From: MORASH, MELANIE
Sent: Monday, August 12, 2019 1:36 PM
To: Cashwell, James M CERG
Cc: Jennings, Lynne; DiLorenzo, James; Brandon, William; Jeffrey Brunelle; Jennifer Lambert; Ng, ManChak; Pechulis, Kevin; Kilborn, John
Subject: EPA Comments - Olin's July 25, 2019 Proposed Stream Gauge Locations
Attachments: 08-06-2019_EPA Tech Memo_Olin Stream Gauge Proposal Review.pdf

MEMORANDUM

Subject: Review of recent stream gauging proposals, OCSS, Wilmington, Mass

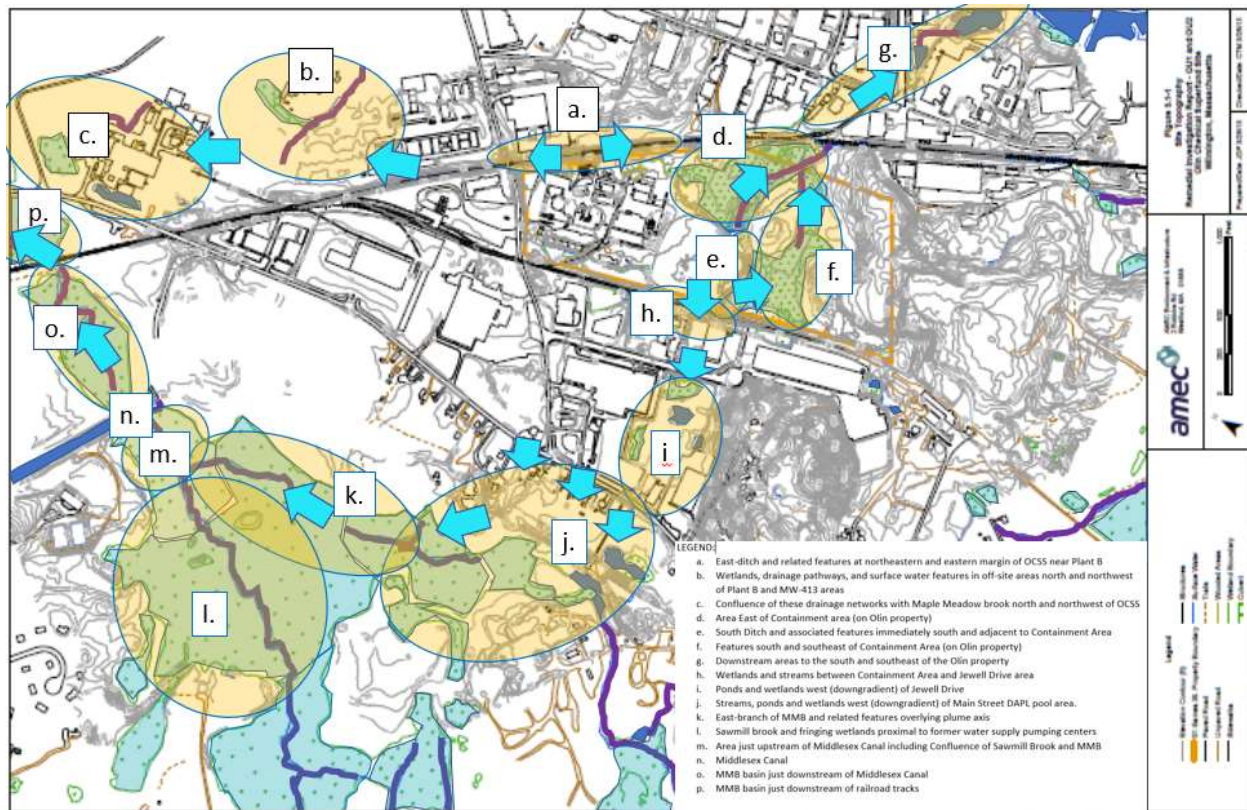
2. *Watershed sub-areas of interest*: In addition to the site-wide scale, it is necessary to provide more detailed representations of surface water and wetland features at many sub-areas of the site. For example, Olin's July 25 proposal discusses Maple Meadow Brook, Area North of Olin (GW-413 Area), and South Ditch at a greater level of detail. It may be advisable to reevaluate potential groundwater/surface-water impacts at other sub-areas of the site, as follows, and highlighted on the figure, below:

- a. East-ditch and related features at northeastern and eastern margin of OCSS near Plant B
 - b. Wetlands, drainage pathways, and surface water features in off-site areas north and northwest of Plant B and MW-413 areas

- c. Confluence of these drainage networks with Maple Meadow brook north and northwest of OCSS
 - d. Area East of Containment area (on Olin property)
 - e. South Ditch and associated features immediately south and adjacent to Containment Area

- f. Features south and southeast of Containment Area (on Olin property)
 - g. Downstream areas to the south and southeast of the Olin property
 - h. Wetlands and streams between Containment Area and Jewell Drive area

- i. Ponds and wetlands west (downgradient) of Jewell Drive
 - j. Streams, ponds and wetlands west (downgradient) of Main Street DAPL pool area.
 - k. East-branch of MMB and related features overlying plume axis

- l. Sawmill brook and fringing wetlands proximal to former water supply pumping centers
 - m. Area just upstream of Middlesex Canal including Confluence of Sawmill Brook and MMB

- n. Middlesex Canal
 - o. MMB basin just downstream of Middlesex Canal
 - p. MMB basin just downstream of railroad tracks

5. Maps from a variety of scales and dates consistently show small but distinct surface water bodies (i.e., ponds) hydraulically downgradient of both the Jewell Drive (off-property) DAPL area as well as downgradient of the Main Street DAPL pool area. These features are shown on the attached figure in the "i." and "j." subareas. The proximity of these features to known shallow pools of DAPL strongly suggests the need for additional monitoring in these features.
